DRAINAGE PLAN

GRADING AND DRAINAGE PLAN
EAST SAN JOSE ELEMENTARY SCHOOL

sheet A-10
of 68

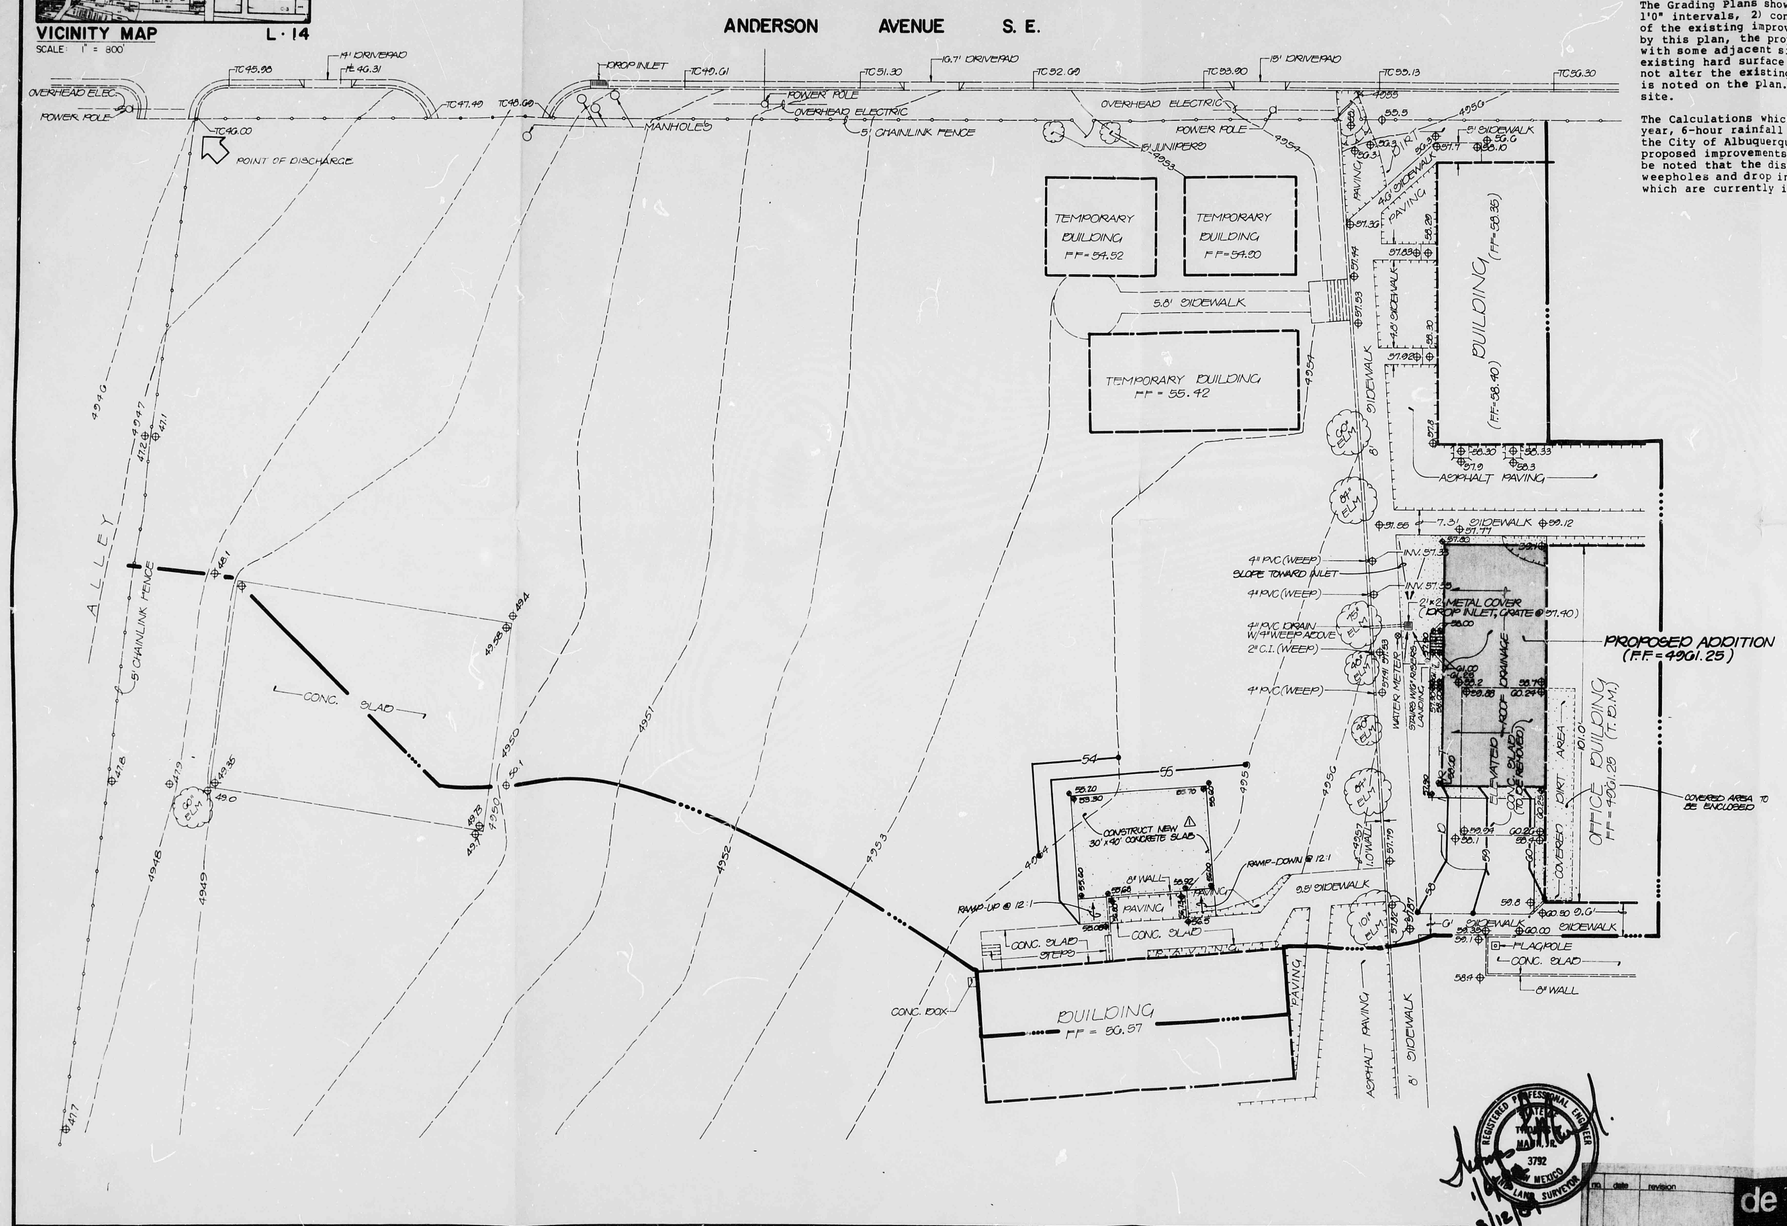
A_{imp} = ~~19,300~~ 20,500 sf △

% impervious = ~~21%~~ 22% △

'C' = ~~0.26~~ 0.27 (DPM Plate 22.2C-1 △

$V_{100} = CP_6A = \cancel{0.26}\,0.25(2.2/12)(92,700) = \cancel{4420}\,4250$ cf △

$Q_{100} = CiA = \cancel{0.26}\,0.27(4.65)(2.1) = \cancel{2.5}\,2.6$ cfs △

$V_{100} = CP_6A = \cancel{0.26}\,0.27(2.2/12)(92,700) = \cancel{4420}\,4590$ cf △

$\Delta Q_{100} = 2.4 - \cancel{2.5}\,2.6 = \cancel{0.1}\,0.2$ cfs (increase) △

$\Delta V_{100} = 4250 - \cancel{4420}\,4590 = \cancel{170}\,340$ cf (increase) △

NO.	DATE	BY	REVISIONS
△	3/84	JGM	ADD CONC. SLAB & ADJUST CALCS.
